REDTAIL RANCH FILING NO. 1

CONSTRUCTION DRAWINGS

OCTOBER 2018

PCD No. SF-18-021

INTERSECTION APPROACH STRIPING

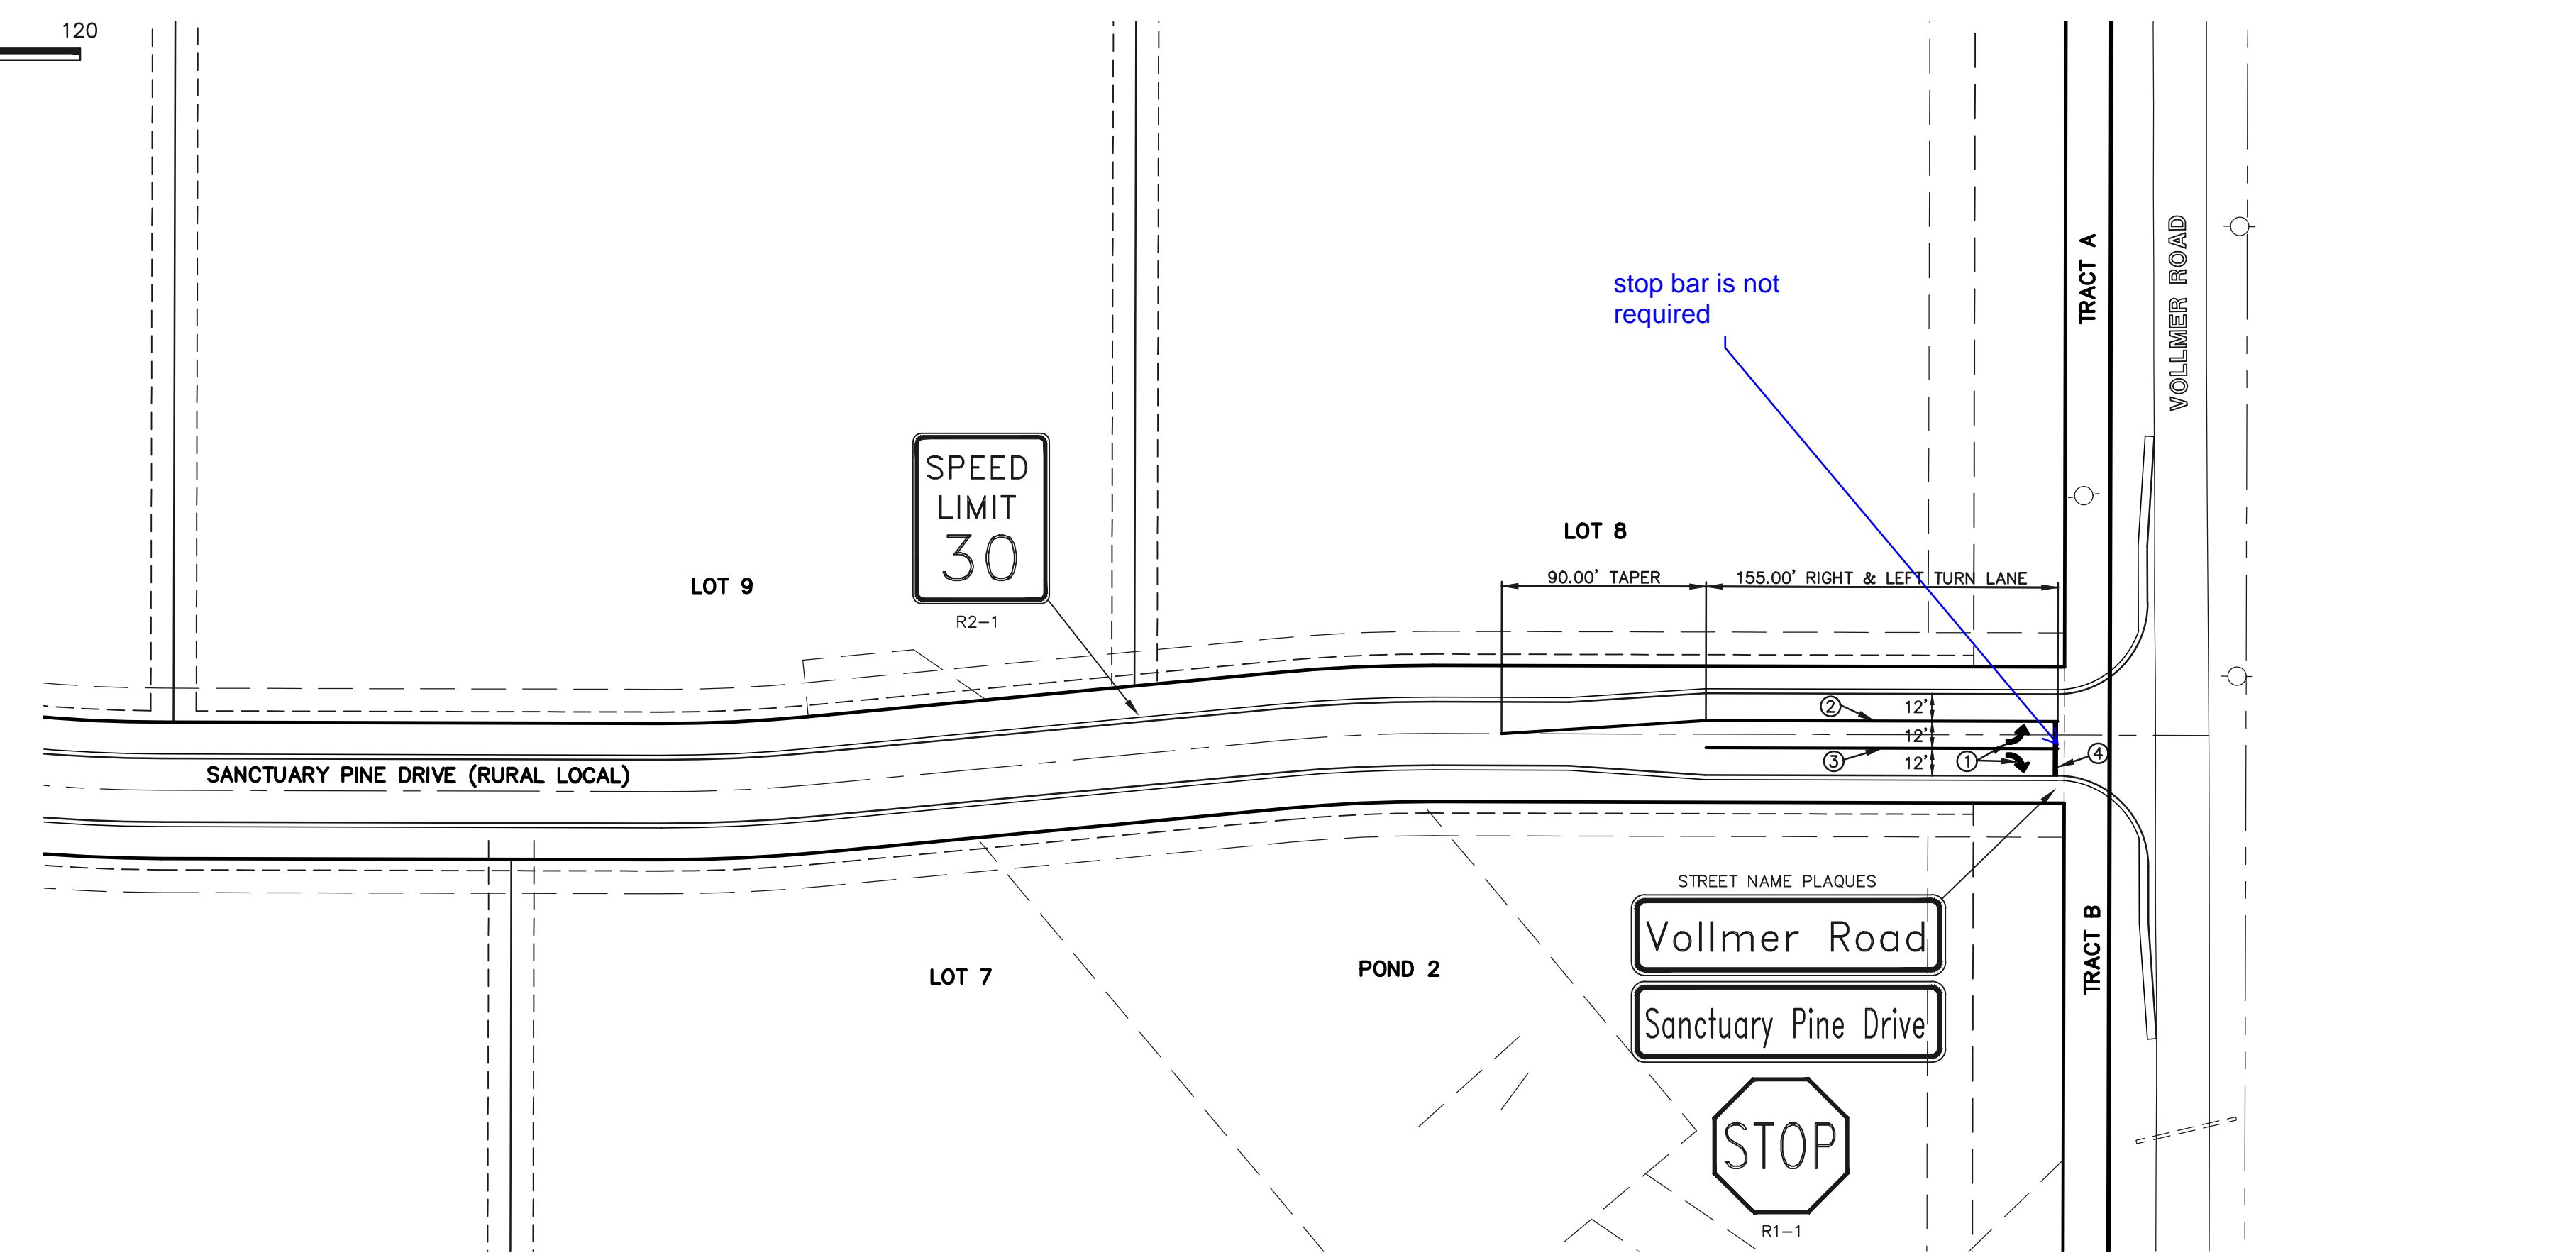
stop bar is not required
